Addendum 8: Regulation No. 9

Revision 2 - Amendment 1

06 series of amendments - Date of entry into force: 8 March 1999

UNIFORM PROVISIONS CONCERNING THE APPROVAL OF CATEGORY L2, L4 AND L5 VEHICLES WITH REGARD TO NOISE

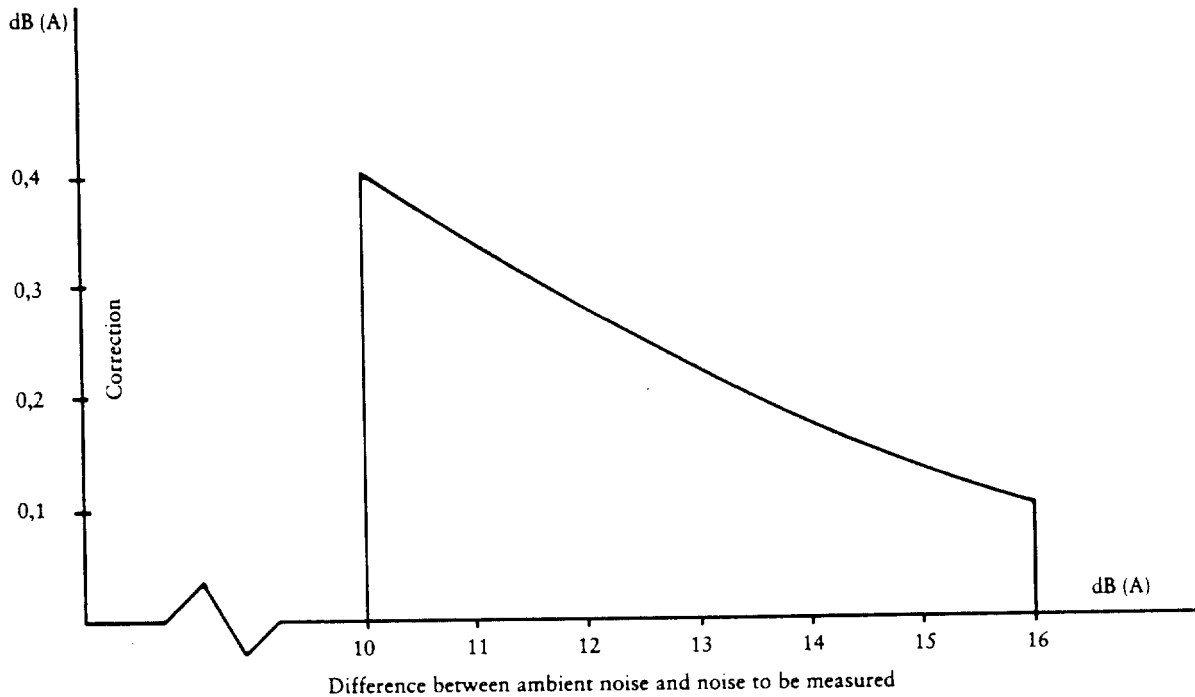
For measurement purposes, the weighted sound-level (A) of sound sources other than on the test vehicle and the sound-level produced by the effect of the wind shall be at least 10 dB(A) below the noise-level produced by the vehicle. The microphone may be fitted with a suitable wind-guard, provided that its influence on the sensitivity and directional characteristics of the microphone are taken into account.

If the difference between ambient and measured noise-levels is between 10 and 16 dB(A), the appropriate figure shall be subtracted from the value recorded by the sound-level metre, in accordance with the following graph:

Annex 3 - Appendix, amend to read:

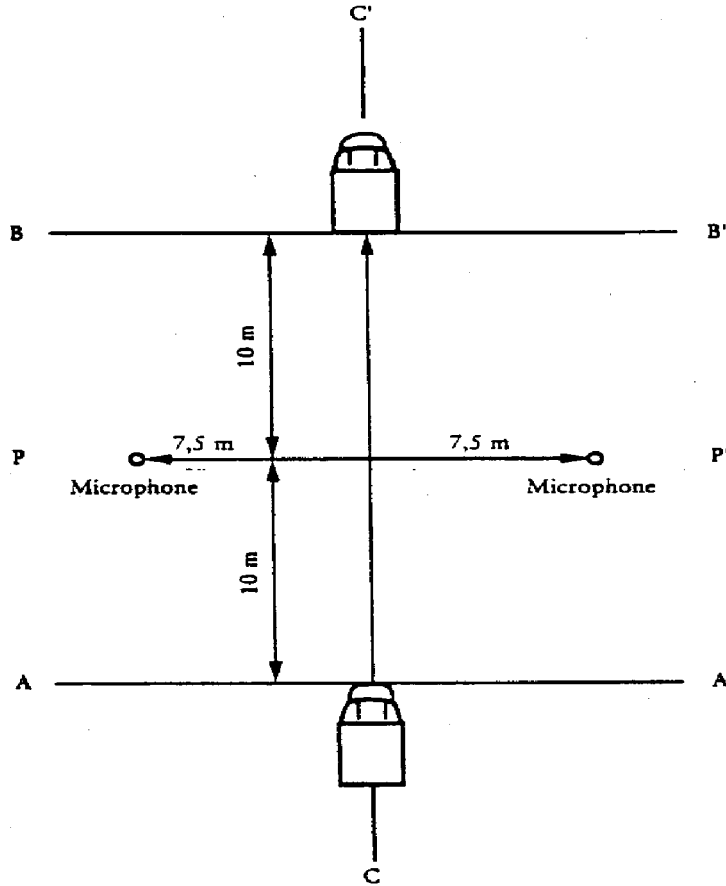
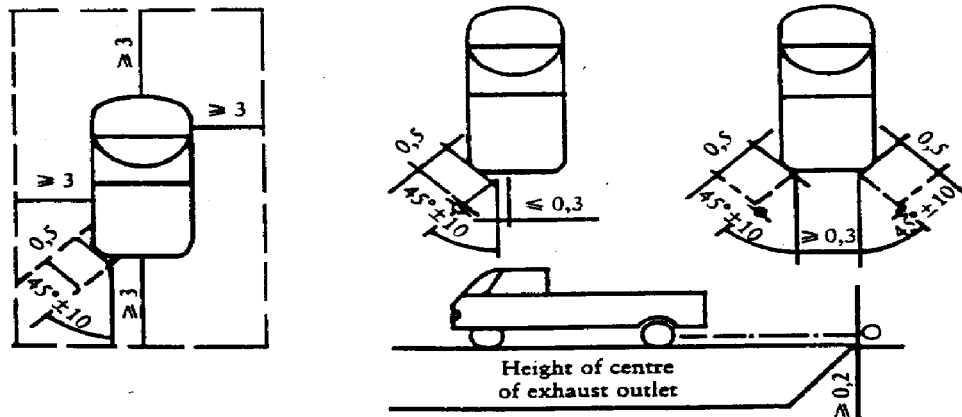
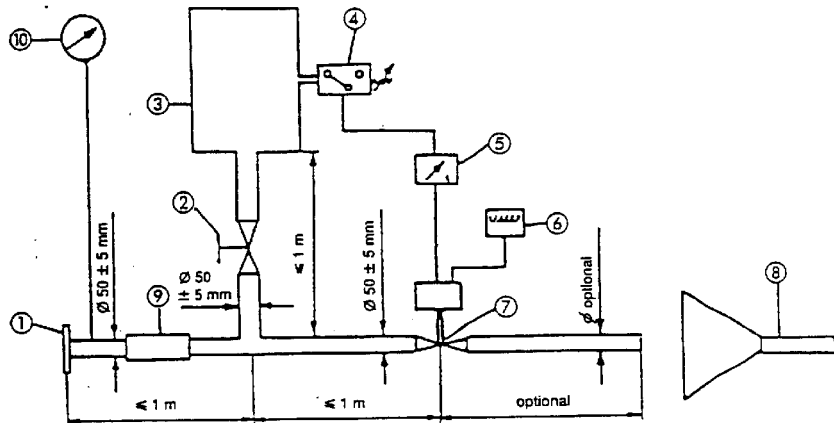
"Annex 3 - Appendix
 Figure 1

Positions for testing the vehicle in motion

Figure 2

Positions for testing the stationary vehicle

Test apparatus for conditioning by pulsation

Figure 3

Figure 1: Minimum requirement for test surface area. The shaded part is called "Test Area".

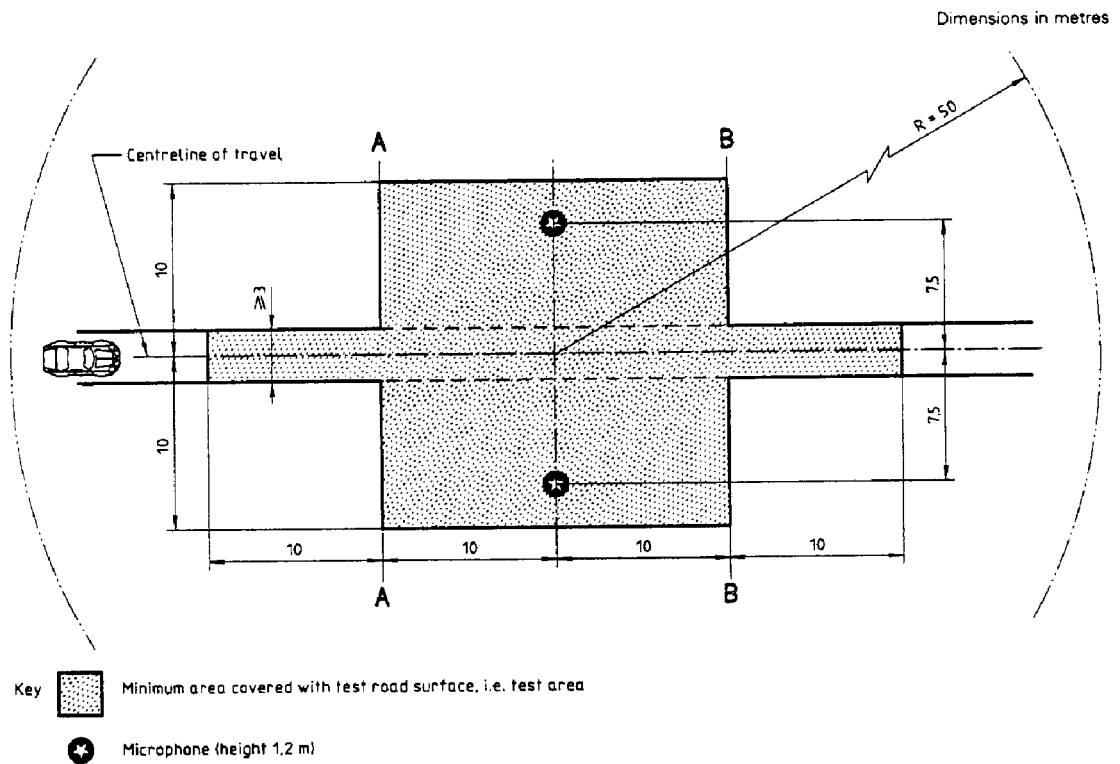
When designing the test track layout it is important to ensure that, as a minimum requirement, the area traversed by the vehicles running through the test strip is covered with the specified test material with suitable margins for safe and practical driving. This will require the width of the track to be at least 3 m and the length of the track to extend beyond lines AA and BB by at least 10 m at either end. Figure 1 shows a plan of a suitable test site and indicates the minimum area which shall be machine laid and machine compacted with the specified test surface material. According to annex 3,

paragraph 3.1.1.1., measurements have to be made on each side of the vehicle. This can be done either by measuring with two microphone locations (one on each side of the track) and driving in one direction, or measuring with a microphone only on one side of the track but driving the vehicle in two directions. If the former method is used, then there are no surface requirements on that side of the track where there is no microphone.

NOTE — There shall be no large acoustically reflective objects within this radius.

Figure 2: Grading curve of the aggregate in the asphaltic mix with tolerances.

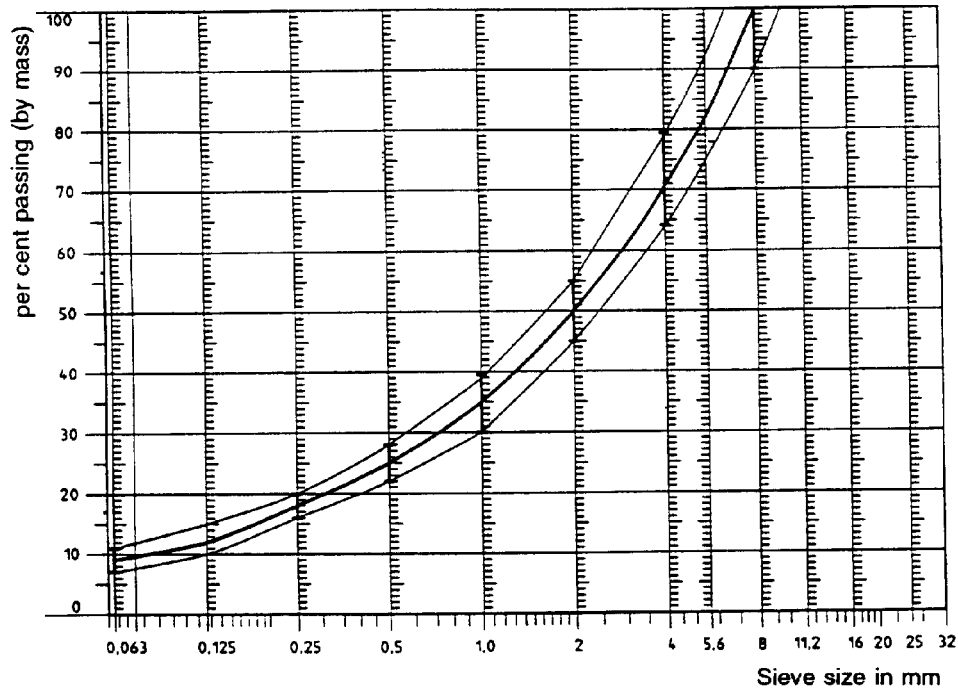
As a guide to the surface constructor, an aggregate grading curve which will give desired characteristics is shown in Figure 2. In addition, Table 1 gives some guidelines for obtaining the desired texture and durability. The grading curve fits the following formula:

$$P (\% \text{ passing}) = 100 \cdot (d/d_{\max})^{1/2}$$

- d = square mesh sieve size, in mm
- d_{\max} = 8 mm for the mean curve
- d_{\max} = 10 mm for the lower tolerance curve
- d_{\max} = 6.3 mm for the upper tolerance curve
